PB#316:
305 Webster Avenue Condominiums
305 Webster Avenue
Cambridge, MA 02139

We are excited to present our updated design to the Planning Board, and we would like to provide you with a summary of the design changes that have occurred after the September 27th, 2016 Planning Board Review.

Design Changes from the September 27th 2016 Planning Approval Presentation:

305 Webster Avenue Condominiums
Building Permit Application Review
June 30th 2017

Design Update - Design Changes

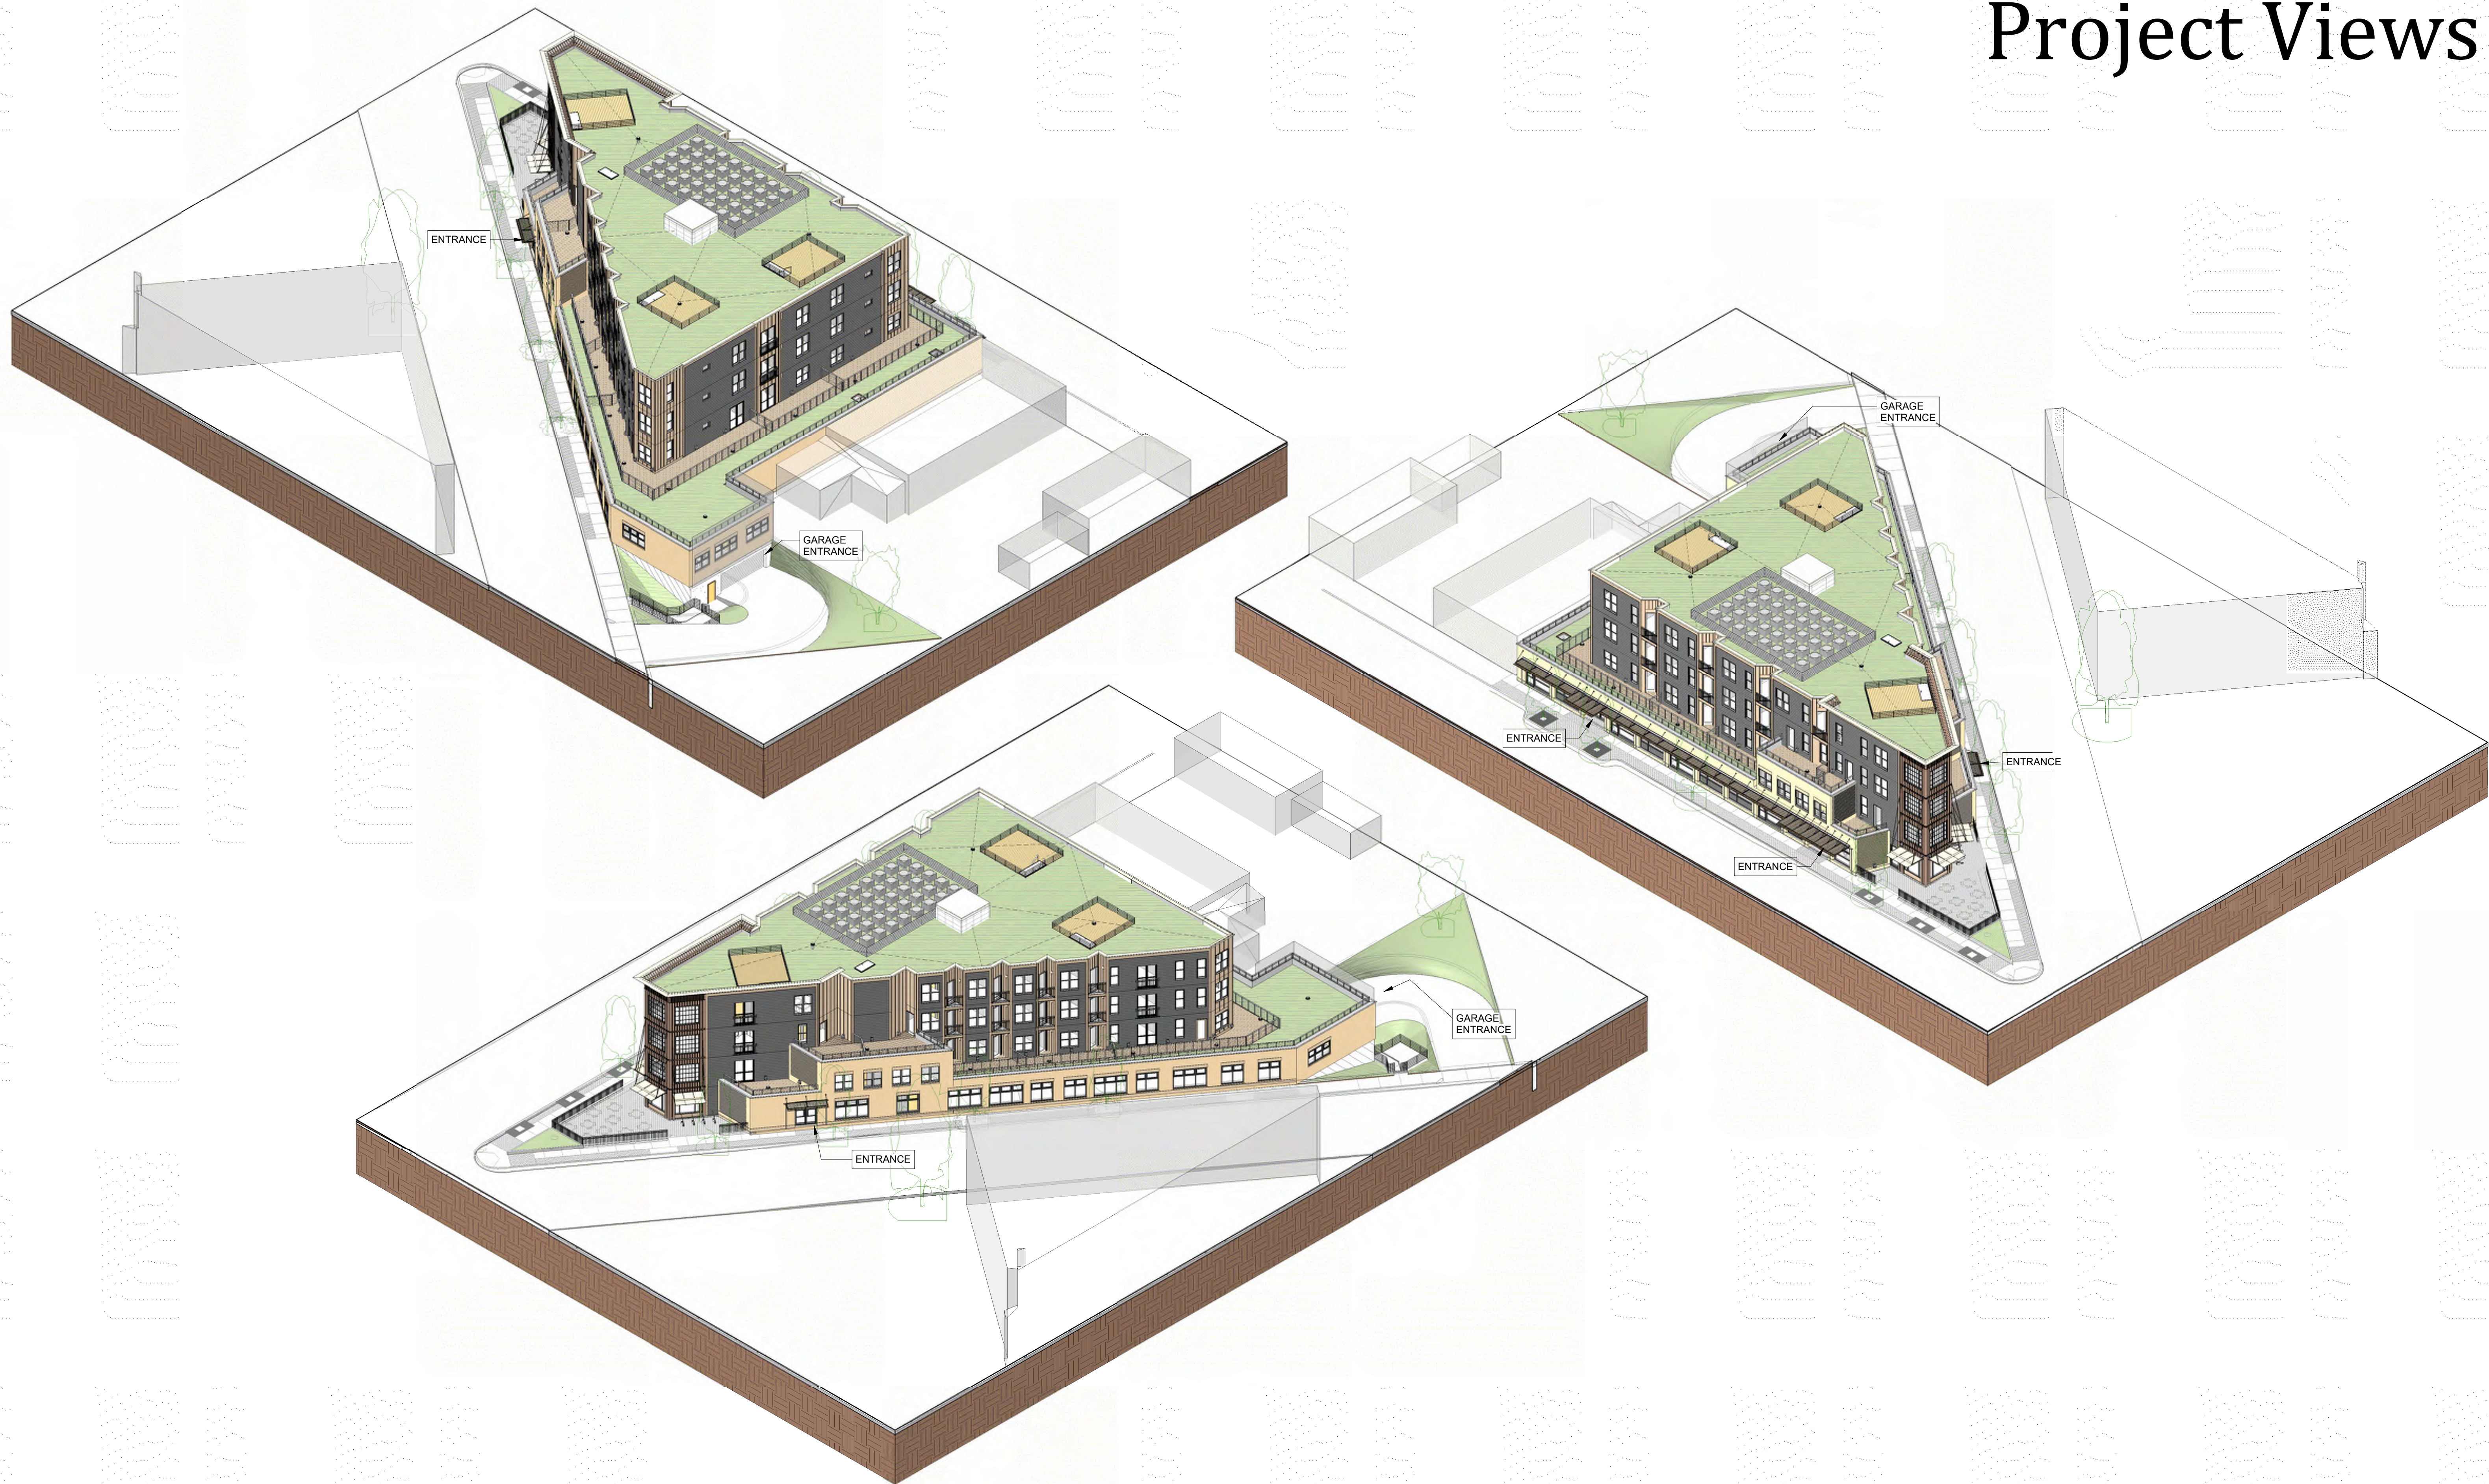
1. Corten Steel Cornice Added
 - a. The Corten Steel Cornice is made of Corten steel plate and Corten steel channel sections. The design is intended to mark the prominent South Corner of the building with a distinctive architectural form, that is both visually light in its thinness, and eye catching in its silhouette.
 - b. The September 27th, 2016 presentation did not include a cornice feature in its presentation.
2. Corten Steel Channel Façade
 - a. The Corten Steel Channel Façade is made of Architecturally Exposed Structural Steel MC8x9 channels, which are assembled into a rain-screen façade at the South Corner of the building. The channel façade is a play on the area's history of light industry and scrap yards, and uses the raw structural steel channels as an homage to the site's history.

- b. The September 27th, 2016 presentation included a generic zinc metal shingle in its presentation.
3. Corten Steel Retail Canopy
 - a. The Corten Steel Retail Canopy is a continuation of the Corten design aesthetic featured in the metal channel façade and cornice. The steel plates in the canopy also continue the theme of mass and lightness explored in the Corten Steel Cornice (item #1)

- b. The September 27th, 2016 presentation included a generic fiberglass cornice in its presentation.
4. Corten Steel Wall Panel
 - a. We have updated the cut-out balconies to show a Corten break-form wall panel at the balconies and building trim. This Corten panel is intended to continue the material theme explored at the South Corner of the building

- b. The September 27th, 2016 presentation included a generic zinc metal shingle in its presentation.
5. Grey Fiber Cement Siding
 - a. We have selected a charcoal grey fiber cement panel for the building's siding. This change was made to harmonize the building pallet, and allow the building form of the lower brick levels to be highlighted against a darker background.

- b. The September 27th, 2016 presentation included a green fiber cement siding in its presentation.
6. Picket Railing
 - a. We have selected a wrought iron picket railing for use at the balconies. This change was made to help tie the trim work of the windows and copings into a single visual layer in the façade.

- b. The September 27th, 2016 presentation included a metal mesh screen railing in its presentation.
7. Parapet Screen
 - a. The parapet screen will be made of painted metal angles with a staggered-slot perforated metal panel, also painted black. The Parapet Screen enables our building to lower the parapet height of the street wall. The Parapet Screen also provides a clean continuous element that helps to visually trim the building's massing.

- b. The September 27th, 2016 presentation included a series of brick piers and infill metal panels in its presentation.
8. Roman Brick
 - a. The team has selected a Roman Brick for the exterior brick walls of the project. This change was made to provide a more up-scale feel to the ground level of the building. The longer aspect ratio of the Roman Brick also helps to provide a more linear horizontal reading of the brick coursing.

- b. The September 27th, 2016 presentation included a standard yellow brick in its presentation.
9. Wood & Glass Canopy
 - a. The team has included an architectural glass, steel, and wood canopy along the length of the Webster Avenue storefront. The new canopy serves several purposes, first, is the weather sheltering that the canopy will provide for the

entrances along Webster Avenue, second, the canopy will create a shadow play of light along the ground level, and third, the continuous canopy will help to provide a scalar transition from the street level to the upper levels of the building.

- b. The September 27th, 2016 presentation included a fabric awning in its presentation.

10. Dark Window Frames

- a. The dark window frames were selected to compliment the post-industrial aesthetic of the building. The divided light windows at the south corner, the storefront, and double hung windows all have dark exterior frames.
- b. The September 27th, 2016 presentation included sliver aluminum window frames in its presentation.
